Access Compliance Report

Public Rights-of-Way

(Pedestrian Signals)

Intersection ID: N/A	Main Street:	Cross Street: N/A	Location: N/A
ADA ID: 23E5B6DE45E1	Signal Type: One Push Button-APS	Overall Compliance: No	Severity Score: BTN 1: N/A BTN 2: N/A No BTN: N/A
Codes/Mitigation Info/Possible Solution		Field Measurements/Component Compliance

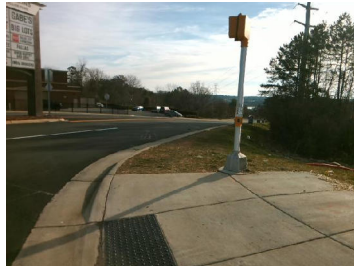
PROW/ADA: TMUTCD 4e.08, R404.2, R404.3, R404.7.2, R209.1, MUTCD 4e.10

N/A	B 1 Clear Xing Direction?	Yes	N/A	B 2 Clear Xing Direction?	N/A
	B 1 Crossing Direction	To N		B 2 Crossing Direction	N/A
No	B 1 DistanceTo XWalk (in)	81.0	N/A	B 2 DistanceTo XWalk (in)	N/A
No	B 1 DistanceTo Curb (in)	80.0	N/A	B 2 DistanceTo Curb (in)	N/A
Yes	B 1 Diameter (in)	2.0	N/A	B 2 Diameter (in)	N/A

Possible Solutions: Replace Signal Push Button With APS Button on New Post. Remove & Relocate Sign.
